Inspectors' Matters, Issues and Questions – 3 August 2022

Matter 11: Green and Blue Infrastructure

Issue (i): Is the Plan sufficiently positively prepared, effective, and consistent with both the London Plan and national policy in its approach to green and blue infrastructure?

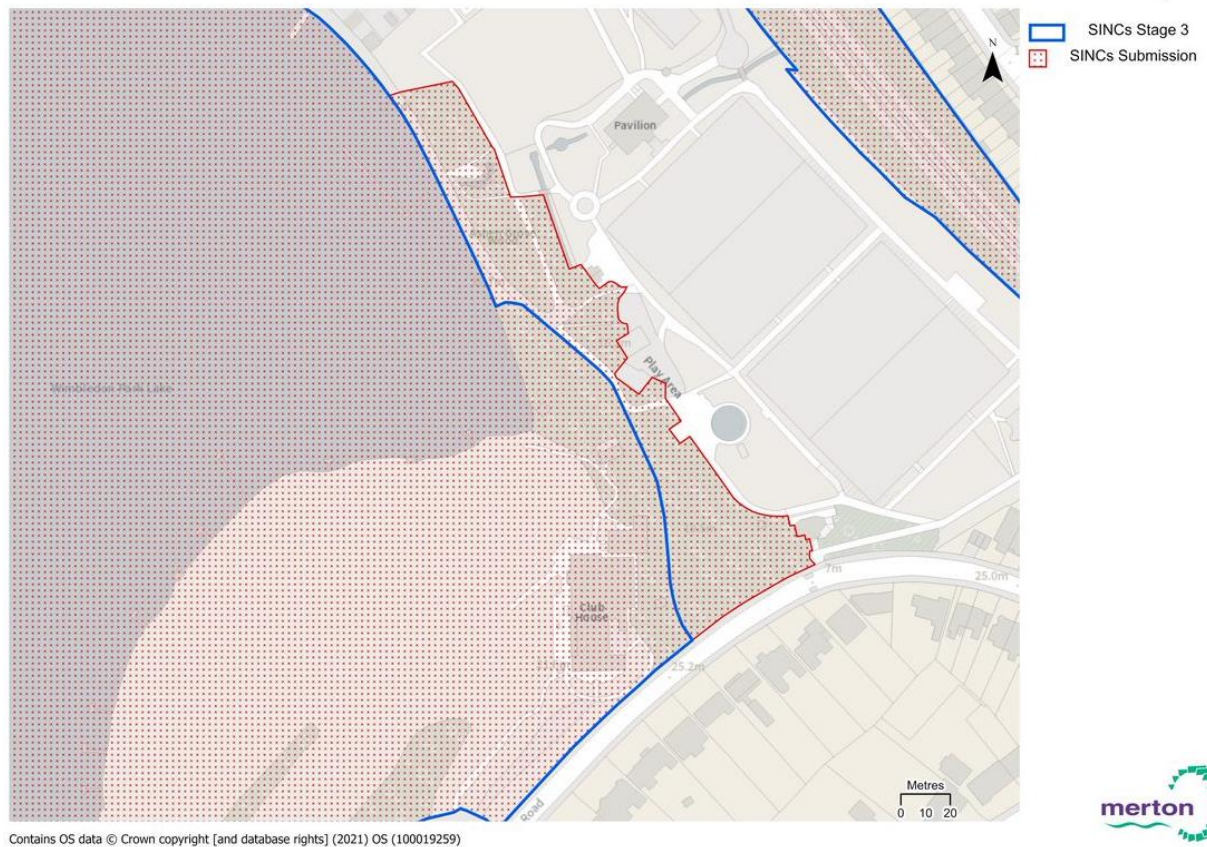
Site	Modification
Part of Wimbledon Park, SW19.	<p>Extension of the Wimbledon Park SINC (Wimbledon Park – Merton Section MeBII02).</p> <p>The modification was highlighted by D. Dawson in his response to the Stage 3 Local Plan. It was then reviewed and confirmed by an ecologist in the council's Greenspaces team. As part of the recent Wimbledon Park Lake project this land has been extensively surveyed and it holds nature conservation interest in line with the SINC designation. It is considered that the site was excluded in error in the 2014 Plan.</p> <p>The council considers that the extension of this part of Wimbledon Park in the SINC Policy Map designation is necessary to ensure that the Local Plan is accurate and 'justified'.</p> <p>Refer to map below.</p>

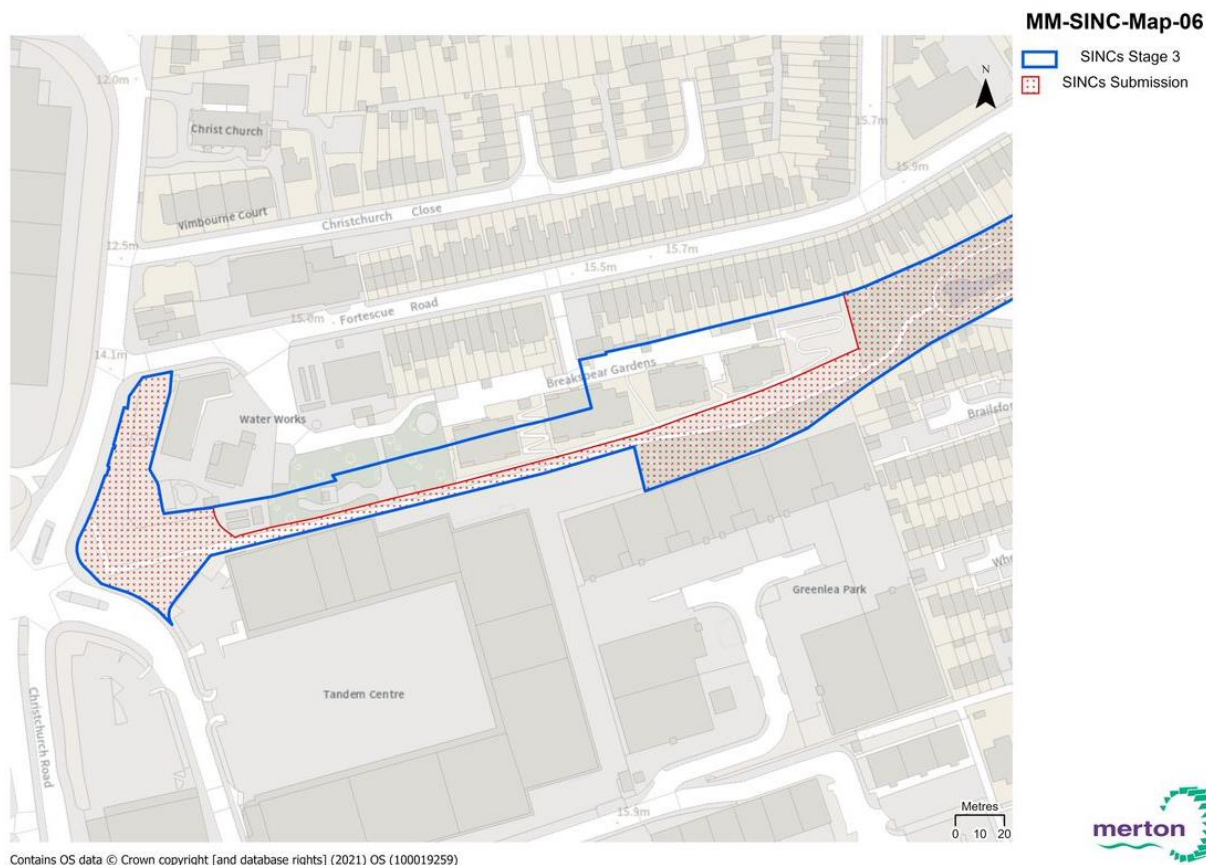
Site	Modification
Part of Breakspear Gardens, Colliers Wood, SW19 2FP.	<p>Removal of part of Breakspear Gardens from Myrna Close Valley SINC (MeBII10).</p> <p>This modification is required to align with the approved Planning Application 16/P3430 to reflect the residential properties that have been built and the new ecology area created on site.</p> <p>The site was reviewed by officers prior to Stage 2a consultation, however it was left off the published map due to a GIS error.</p> <p>The council considers that the removal of this part of the site from the SINC Policy Map designation is necessary to ensure that the Local Plan is 'justified'.</p> <p>Refer to map below.</p>

Image 11.1 – Wandle Valley Green Grid (from the All London Green Grid)

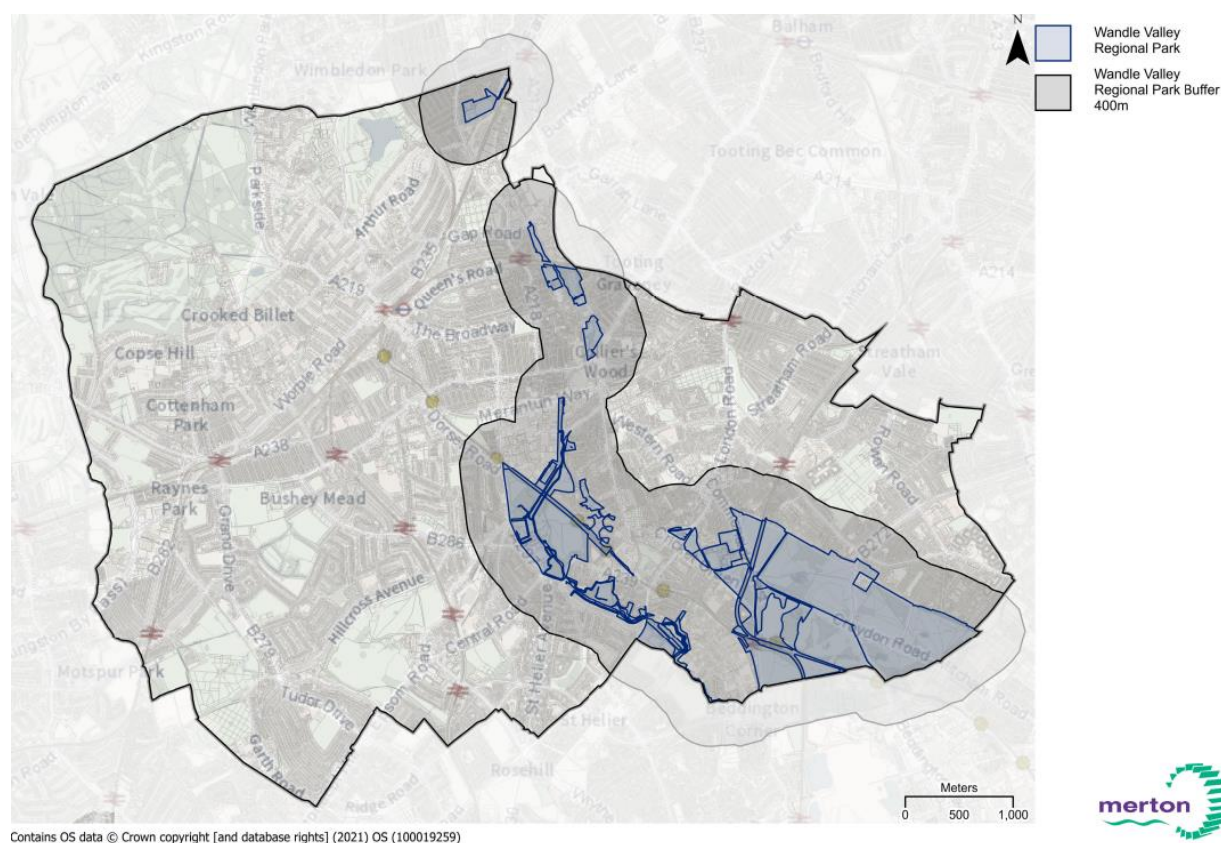
- 11.32 In terms of significance of “greater coverage” shown in the [ALGG Wandle Valley Area Framework 8](#), the map referred to in the Wandle Valley Forum’s response (see Image 11.1 below), shows a strategic boundary, which was drawn to a relatively large scale. There are two areas that contain hatching, which the key depicts as “Metropolitan Park Opportunities” and “Regional Park Opportunities”.

11.35 However, Wimbledon Park is not highlighted on this map with any identifying features in the key, and is not included in the hatched areas.
